# CITY OF ALBUQUERQUE

**RE: 2217 Matthew Ave. NW – Lot 24A  
Grading and Drainage Plan  
Engineer's Stamp Date: 04/03/23  
Hydrology File: G13D044**

Based upon the information provided in your submittal received 04/03/2023, the Grading & Drainage Plan is approved for Grading Permit (earthwork can get started for the earth pad on the house and retaining walls).

ENGINEER'S SEAL  4/3/23	LOT 24-A ALVARDO GARDENS unaddressed MATTHEW AVE portion of 2217 MATTHEW AVE	DRAWN BY DEM DATE 4-1-23
DAVID SOULE P.E. #14522	GRADING AND DRAINAGE PLAN  P.O. BOX 33924 ALBUQUERQUE, NM 87199 (505) 321-9099	SHEET # C1 JOB #

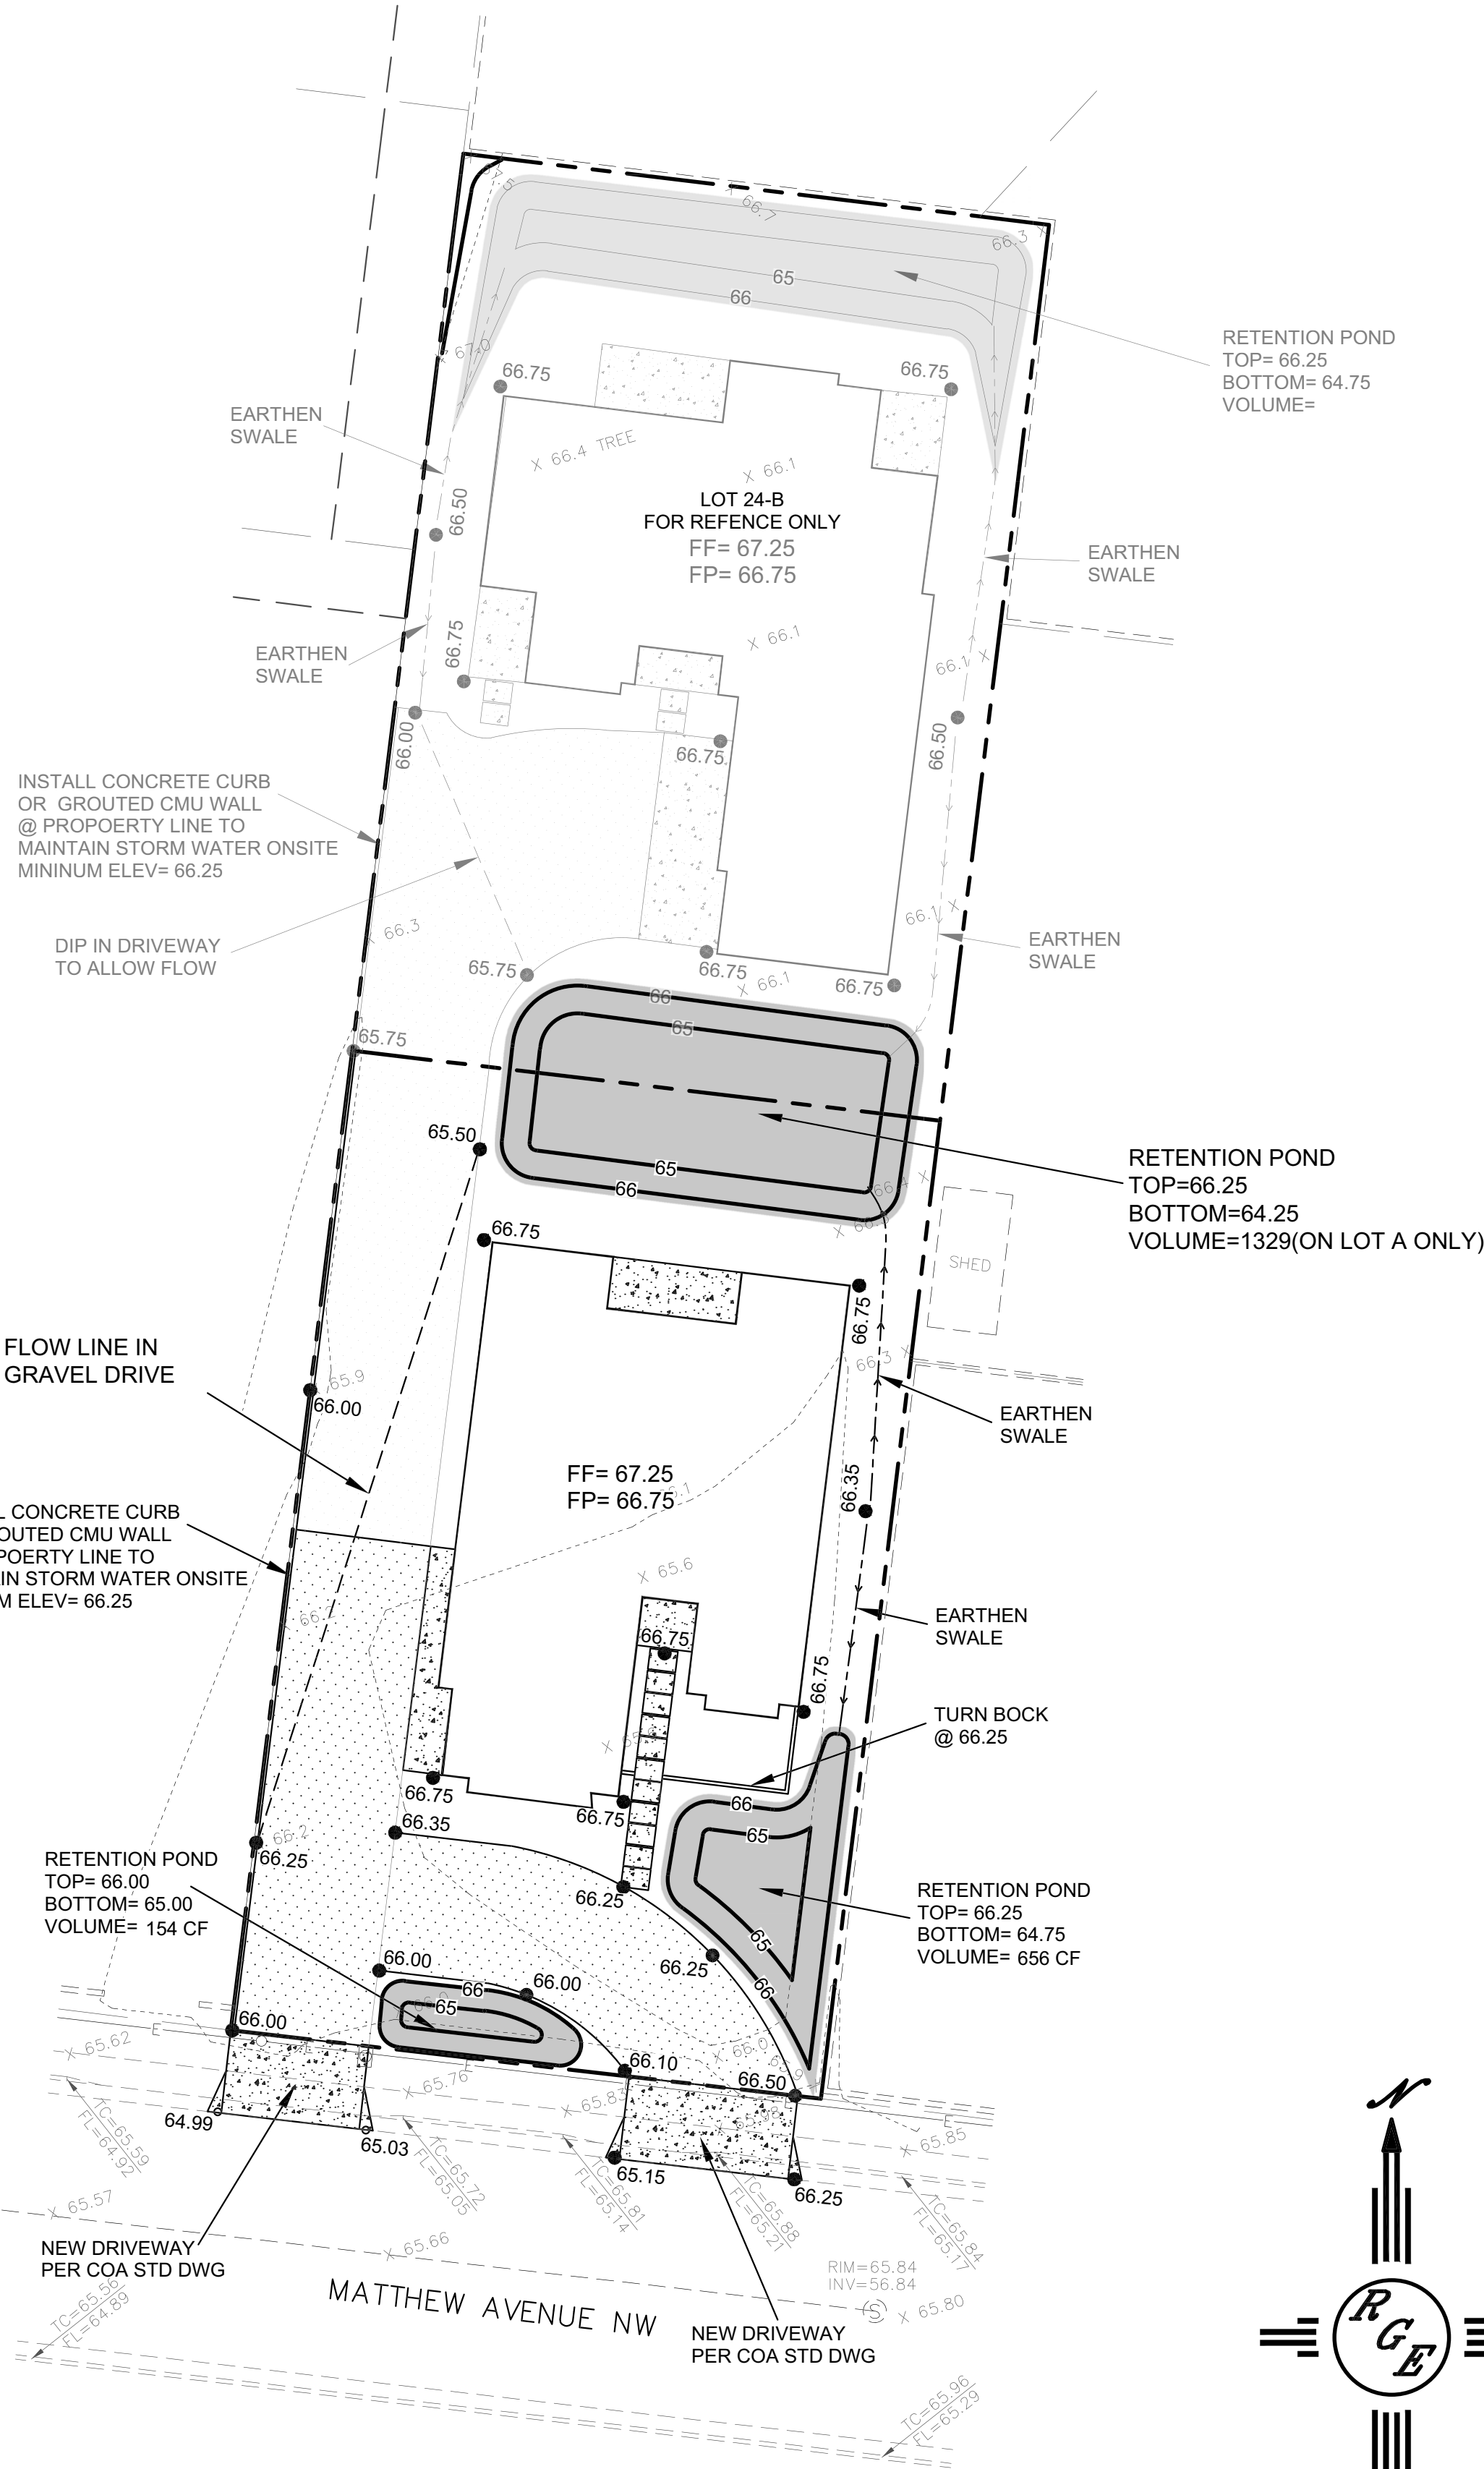
1. Once the grading is complete, a pad certification (meaning that the earthwork and retaining walls are complete) will be required. Please include a site photo with the submittal. Also, at the time of pad certification approval, Hydrology will concurrently approve the Grading & Drainage Plan for Building Permit.
